**City of Portland, Maine - Building or Use Permit Application**

Location of Construction: 43 Fessenden St	Owner Name: Cary John W	Owner Address: 546 Main St	Phone: 207-594-9036
Business Name: n/a	Contractor Name: Brewer Fine Woodworking	Contractor Address: 91 Bell Street Portland	Phone: 2077977534
Lessee/Buyer's Name n/a	Phone: n/a	Permit Type: Alterations - Multi Family	Zone: R-5

REASON FOR PERMIT: Replace Front porch.

**From:** "Michael Locke" <mikeylocke@hotmail.com>  
**To:** "Marge Schmuckal" <mes@ci.portland.me.us>  
**Date:** Thu, Aug 30, 2001 3:39 PM  
**Subject:** 43 Fessenden St.

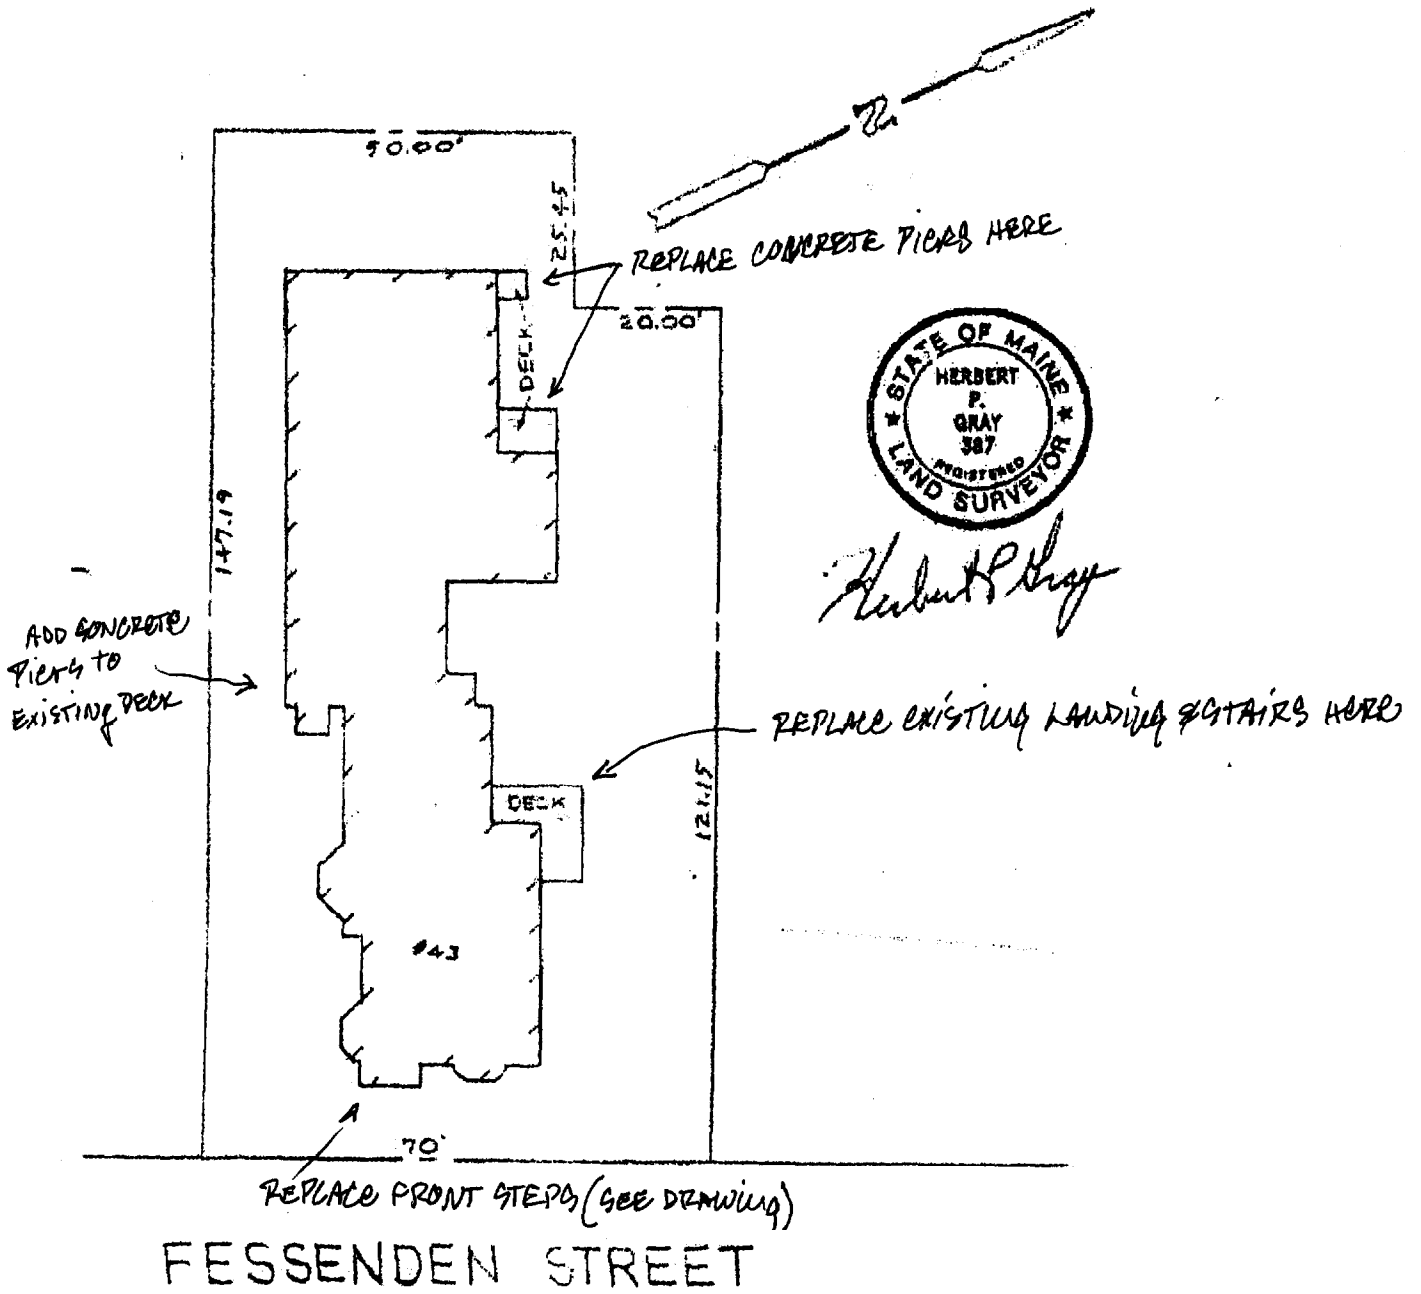
To Expand The original  
footprint ok using Section  
Section 14-440 —  
Needs A landing platform,  
Then Stairs

Front Entry  
 3/4" = 1"

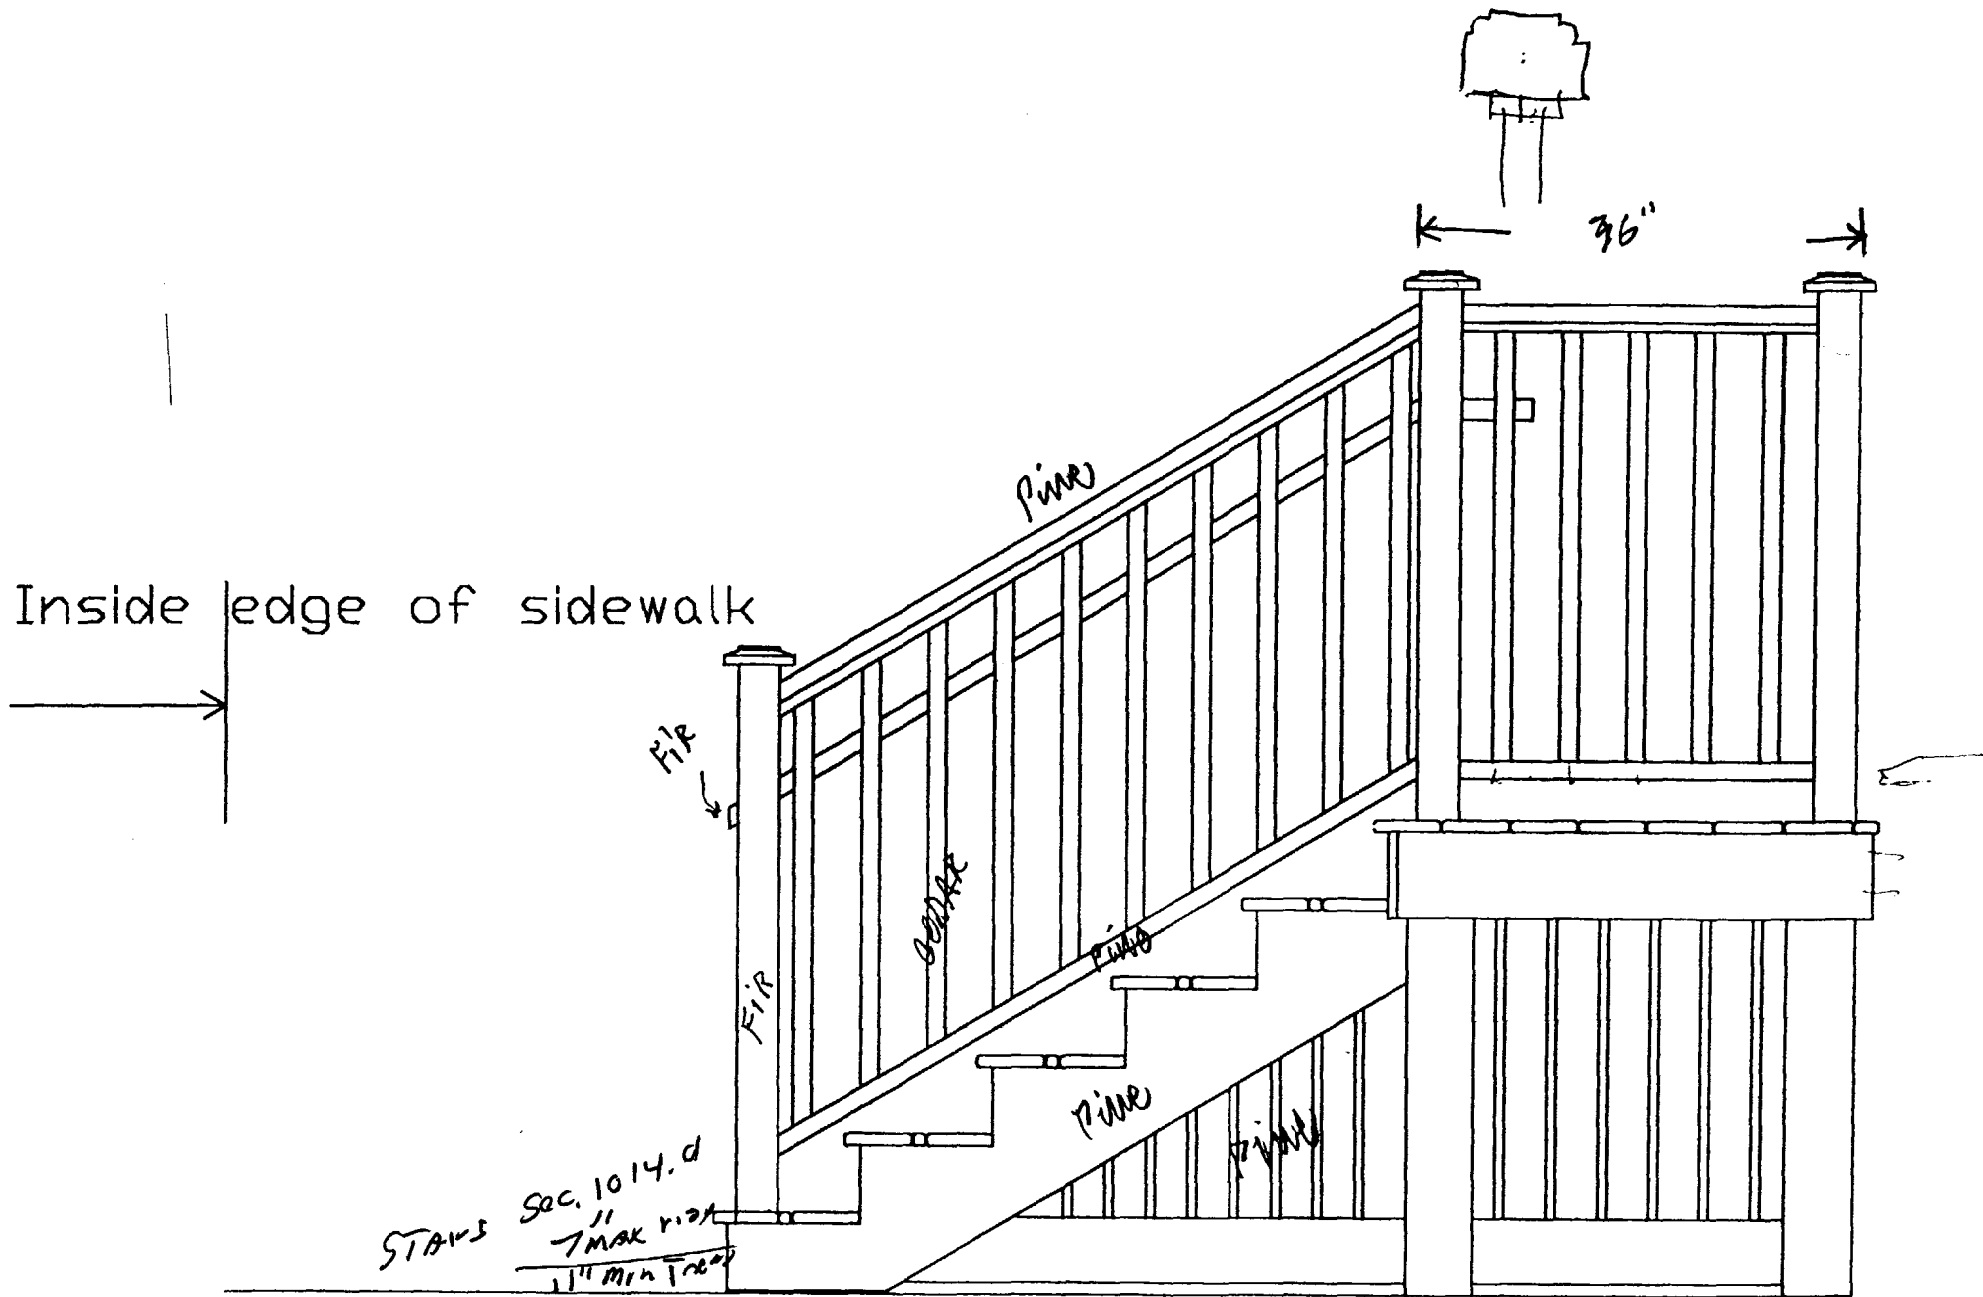
✓ 42" GUARD RAIL HT.  
 ✓ 36" HAND RAIL HT.
